URBAN DESIGN COMMISSION APPLICATION

Address (list all addresses on the project site): 3535-3353 University Ave and 737 & 733 N Meadow Lane

Title: 3575 University Ave

LIGHTING

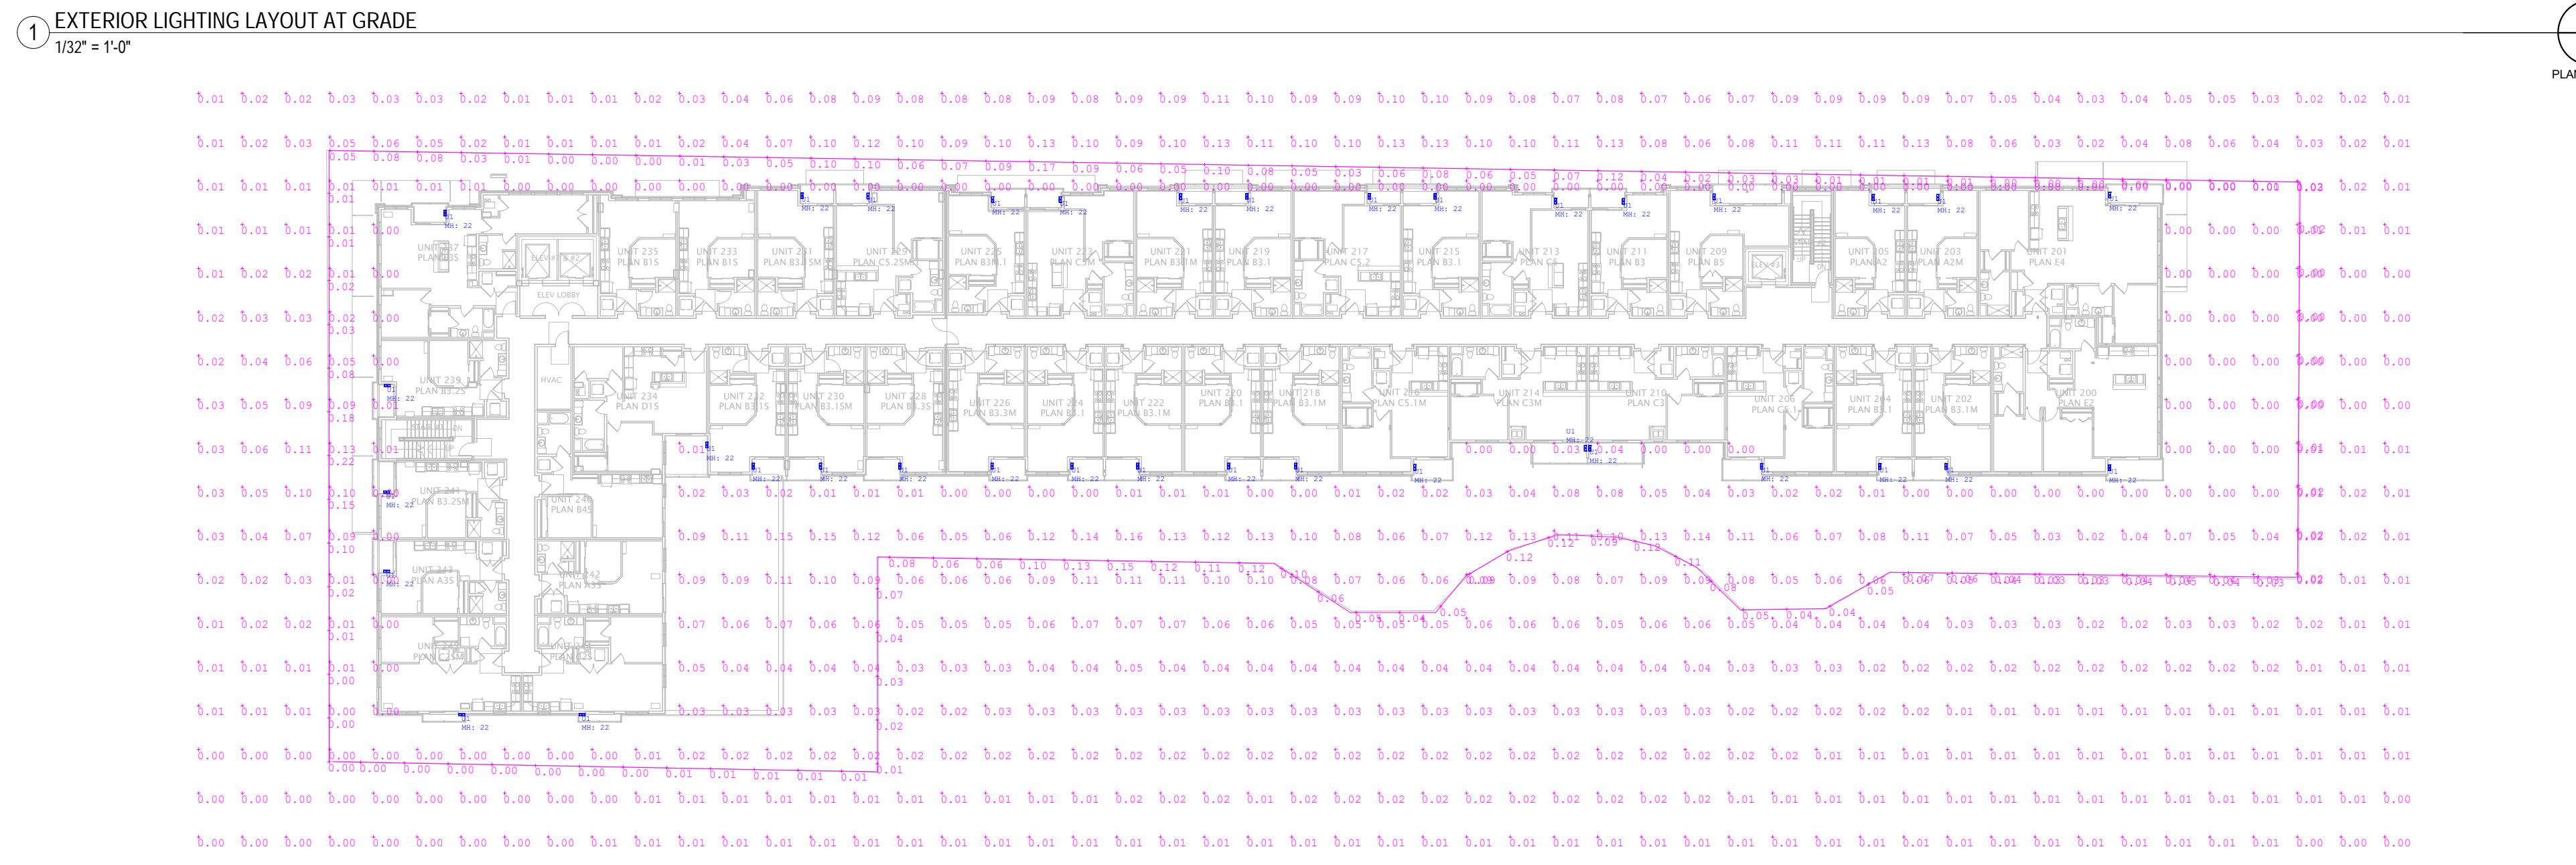
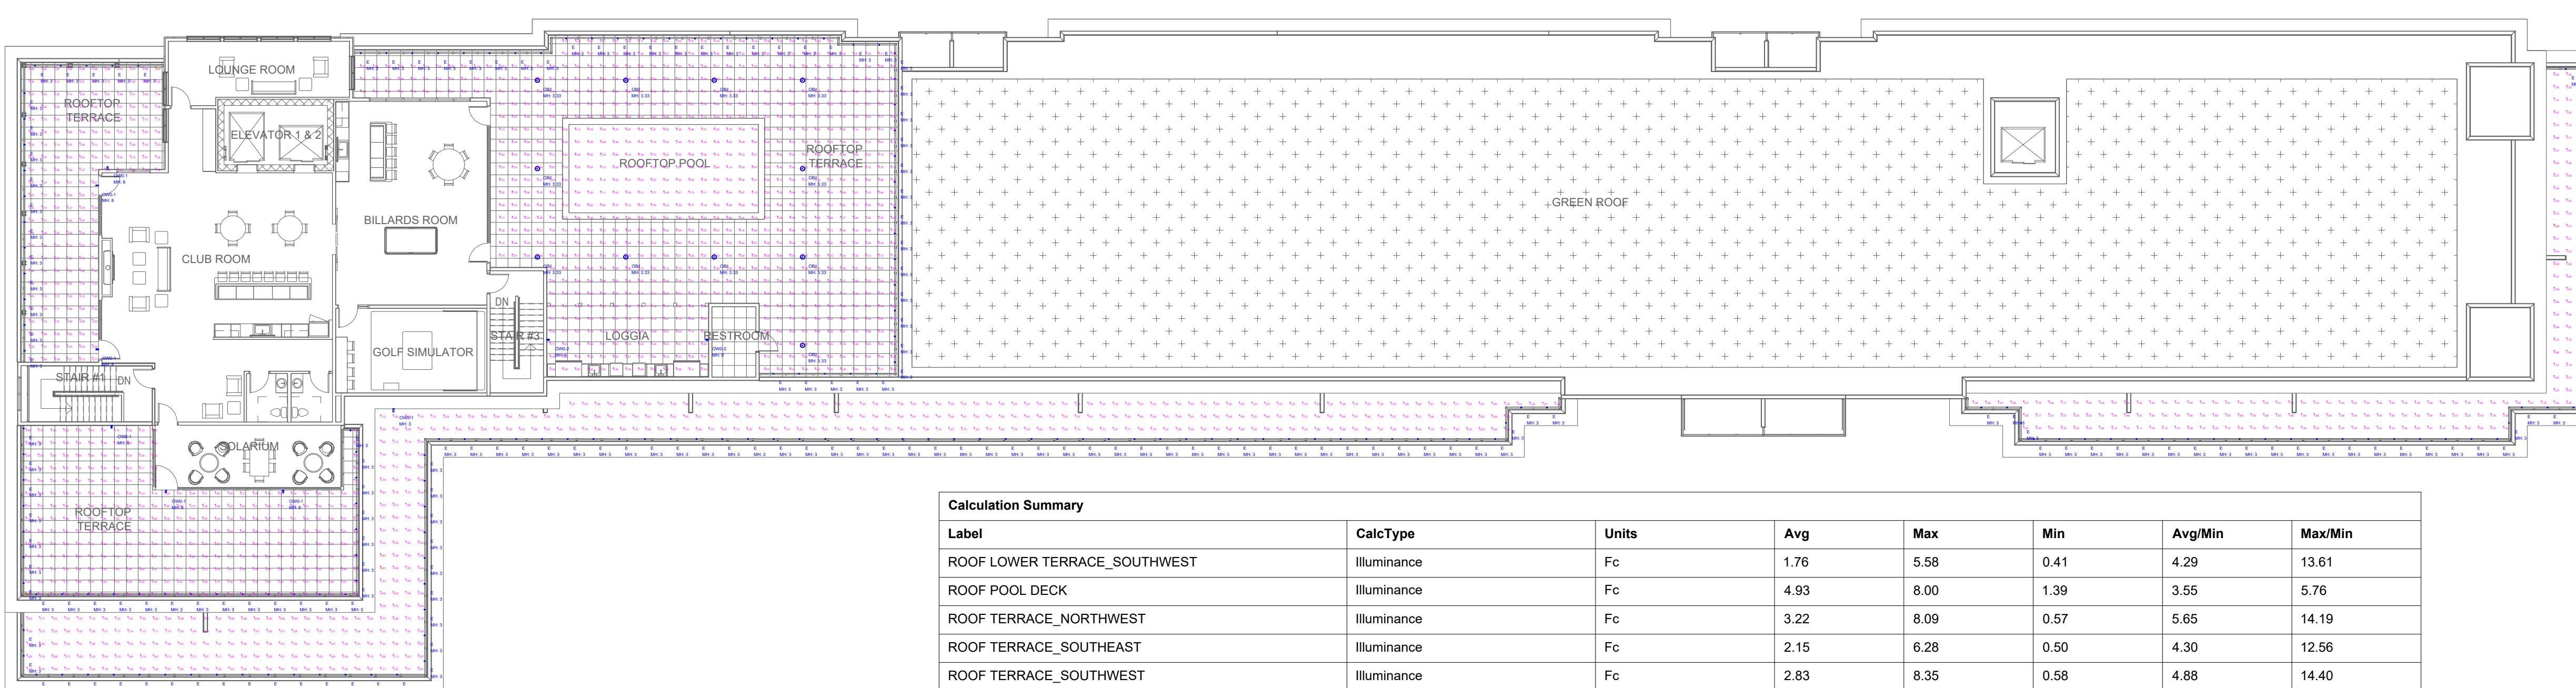
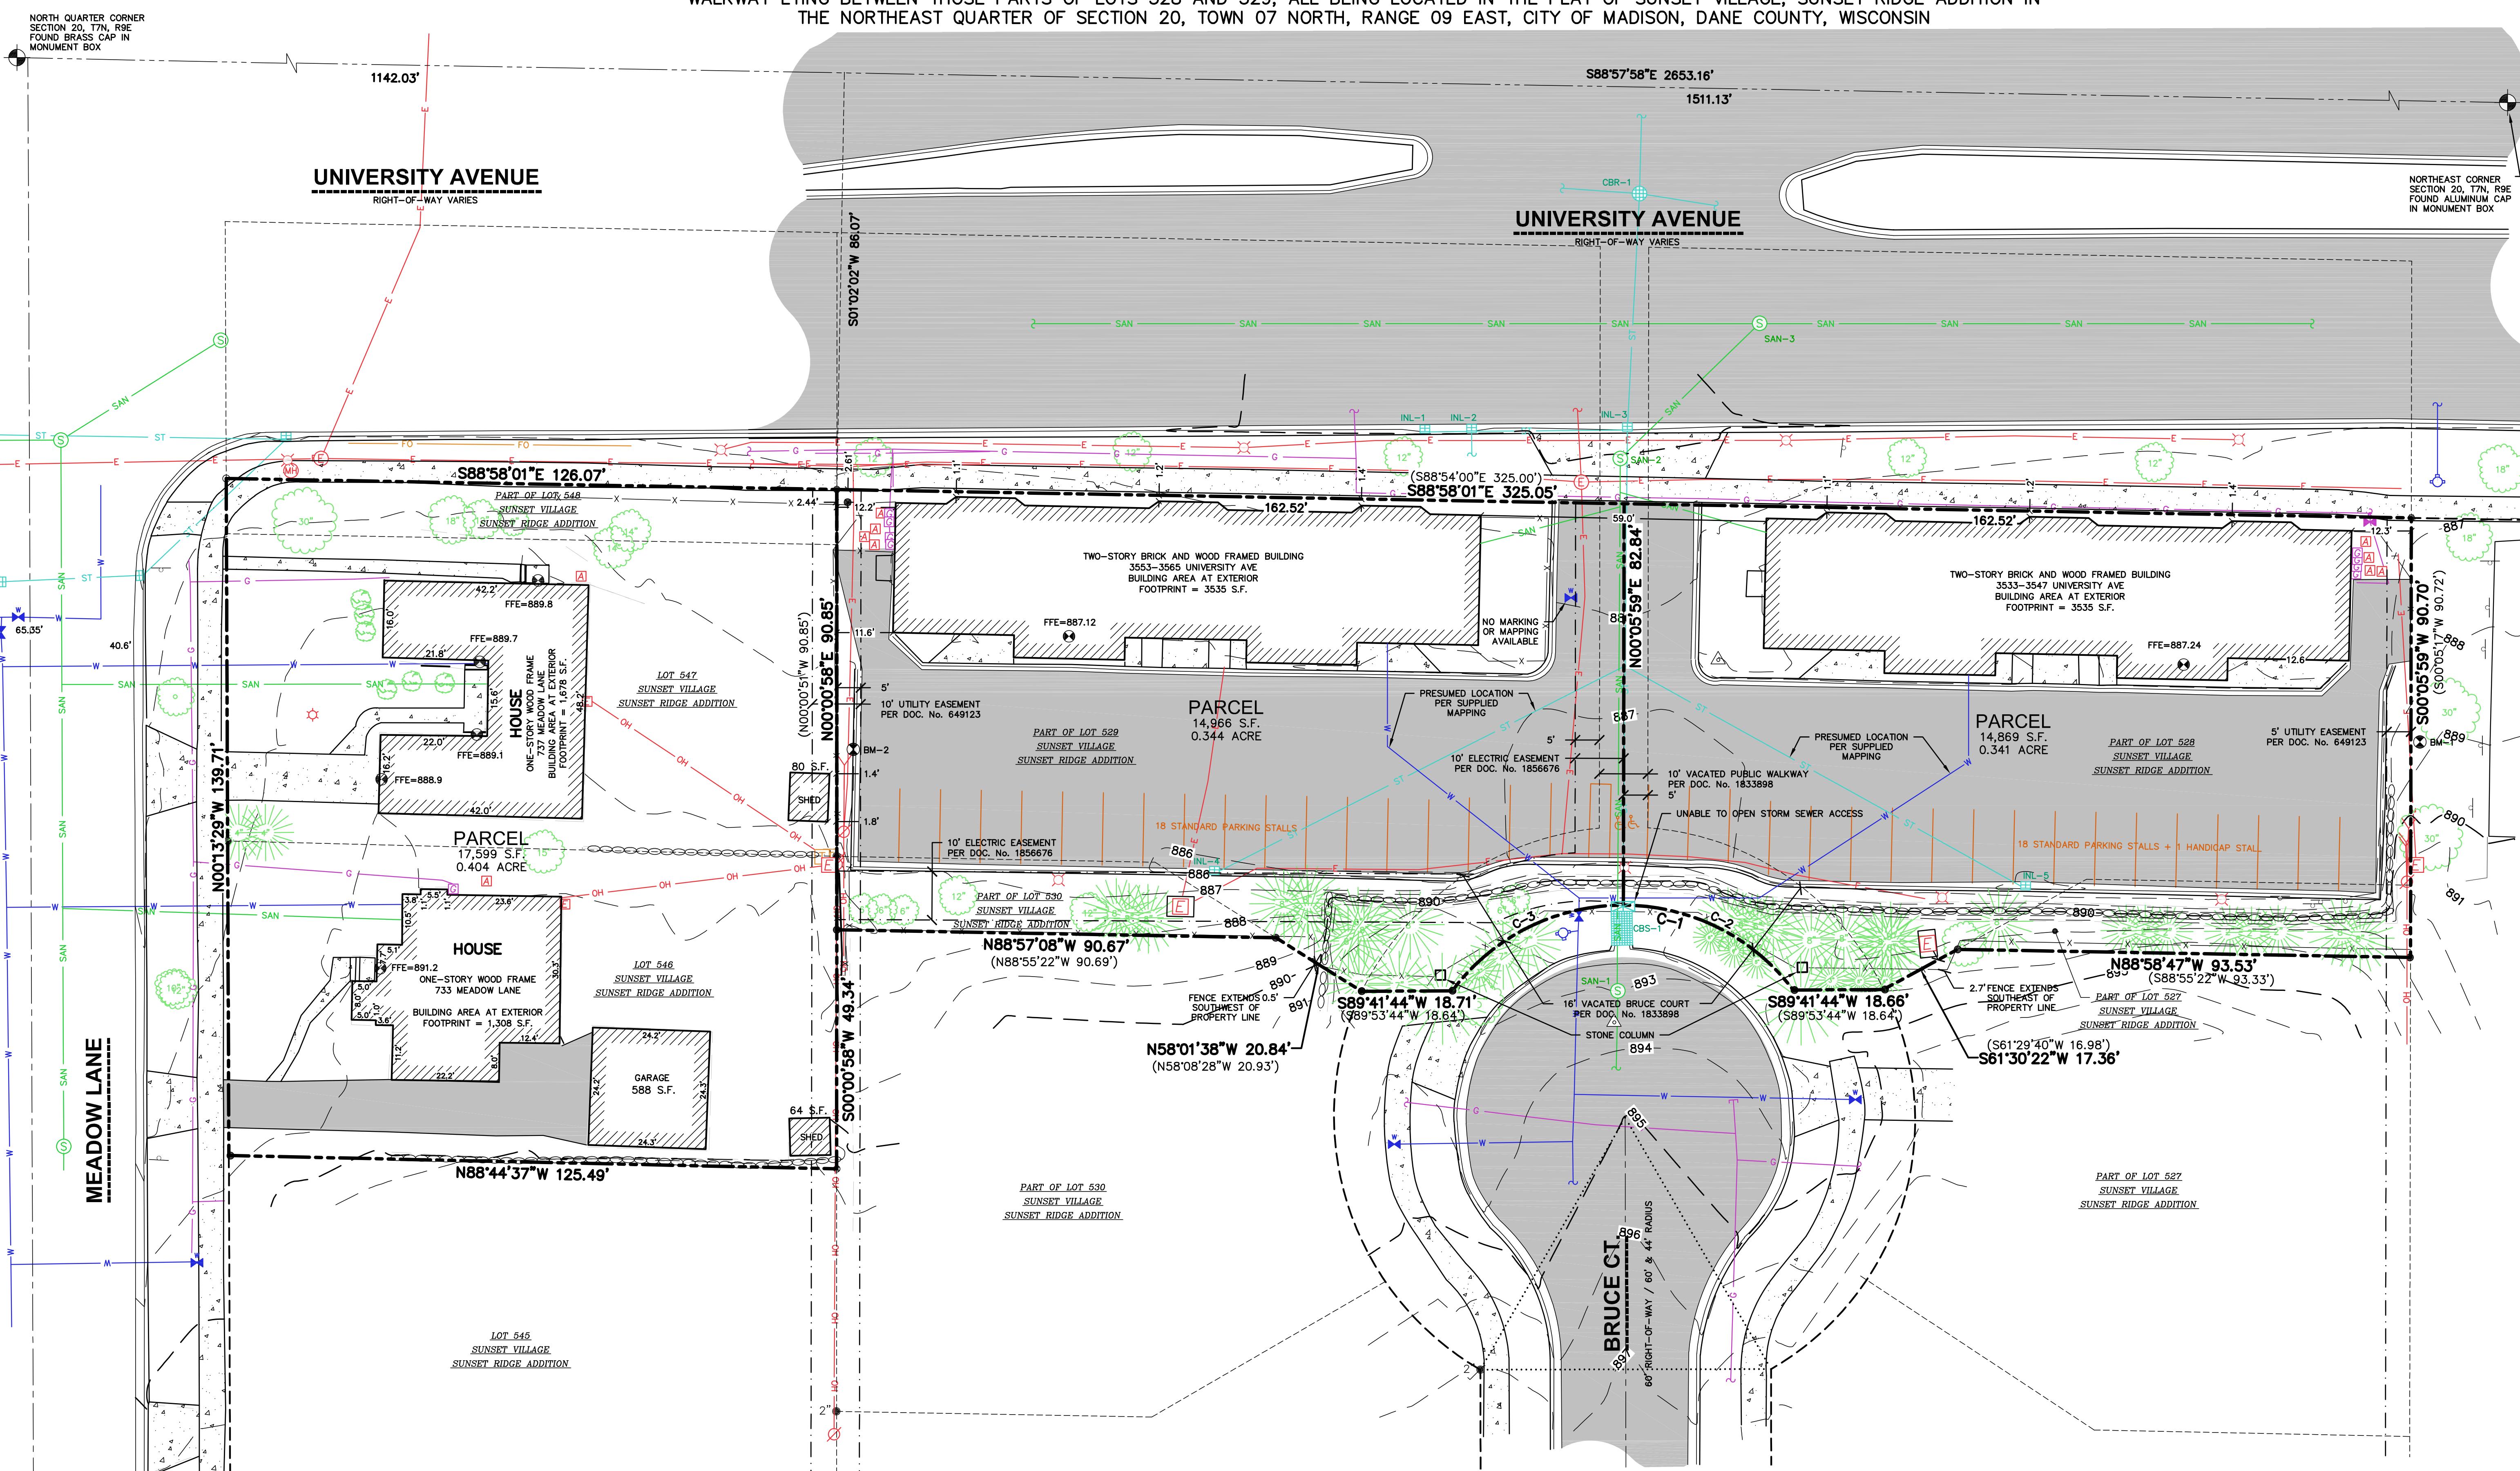
- The applicant shall address the lighting comments noted in the staff report, including revising the lighting plan and providing fixture cutsheets as it relates to rooftop lighting, architectural lighting, individual balcony lighting.

- Rooftop lighting calculations and cut sheets are included in the revised submittal.
 - No architectural lighting or lighting high on the building is included currently.

- The individual balcony lighting cut sheet is included in the revised submittal
 - Balcony lights will be mounted on the recessed wall of the balconies

① NORTH ELEVATION - BIRD SAFE GLASS
1/16" = 1'-0"

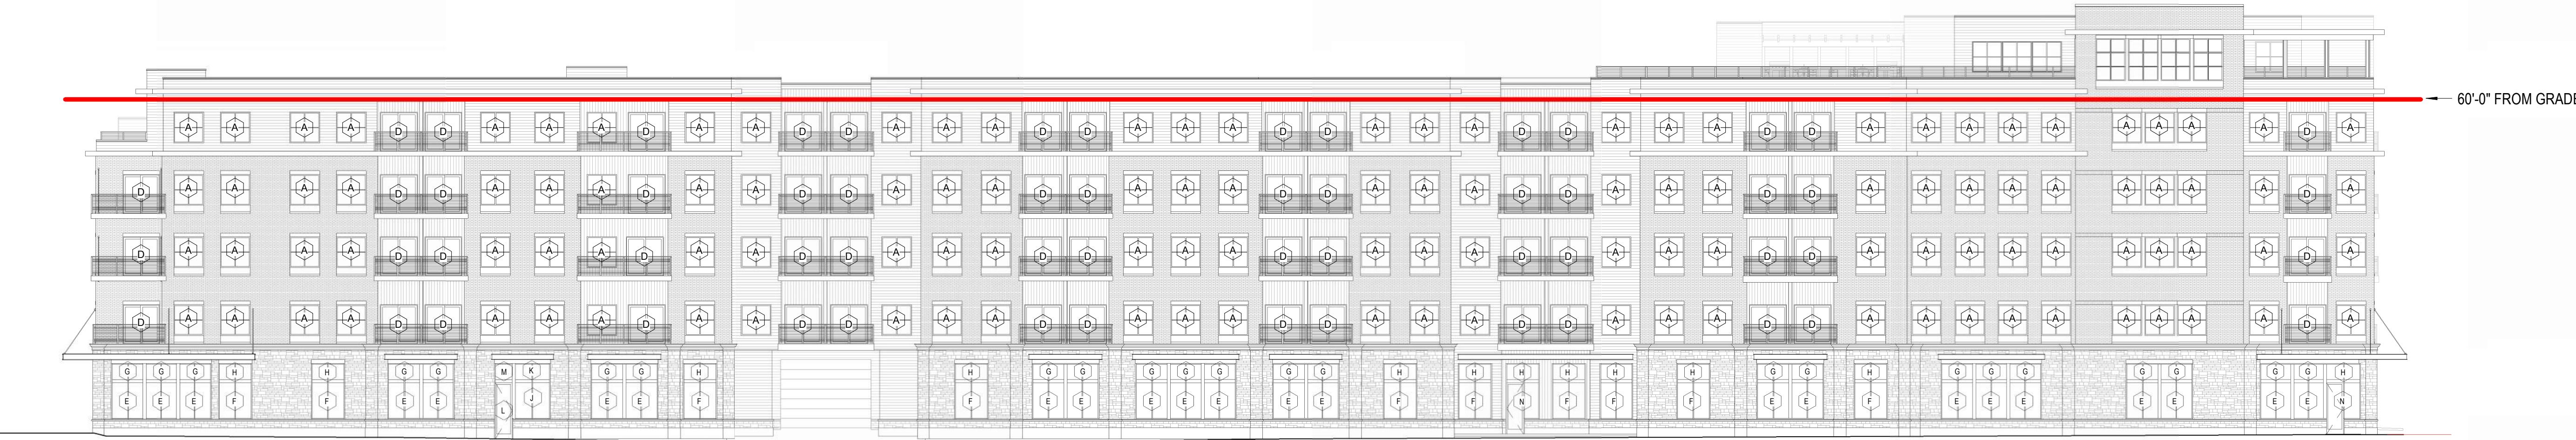
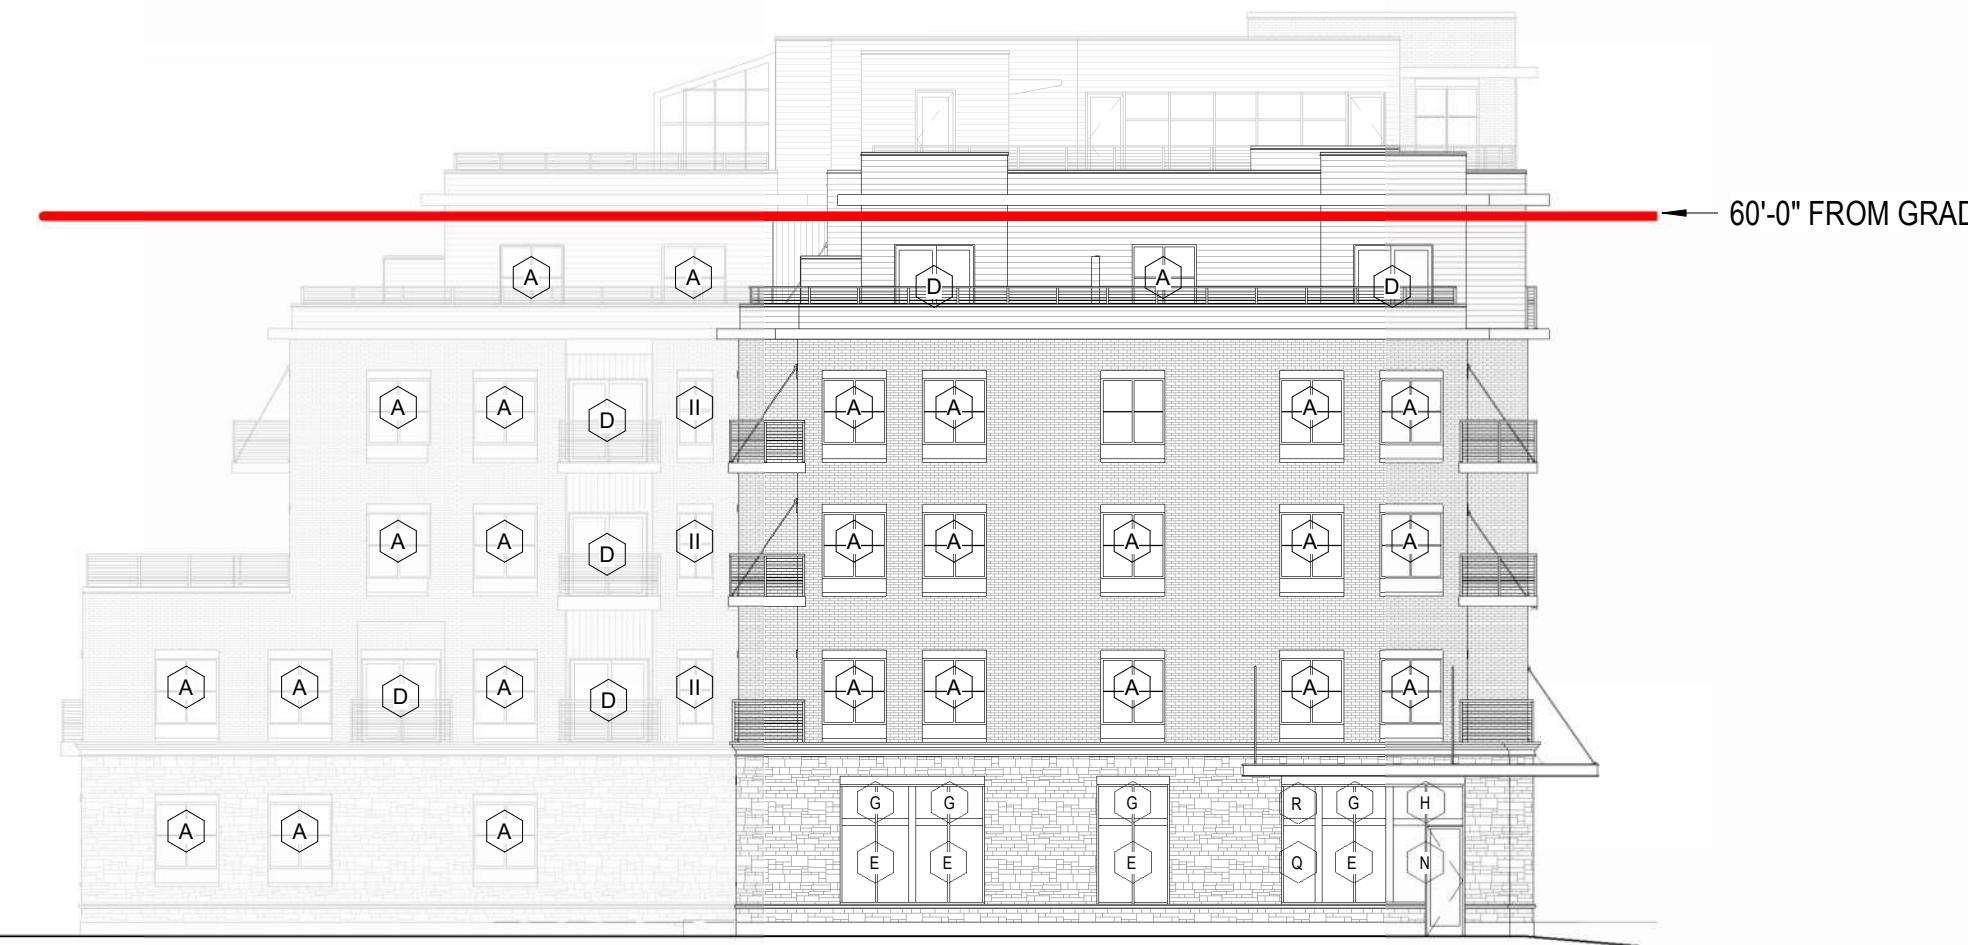
- The applicant shall provide additional details regarding glazing along the ground floor, especially as it relates to the transparency and lighting on both the north and south elevations.
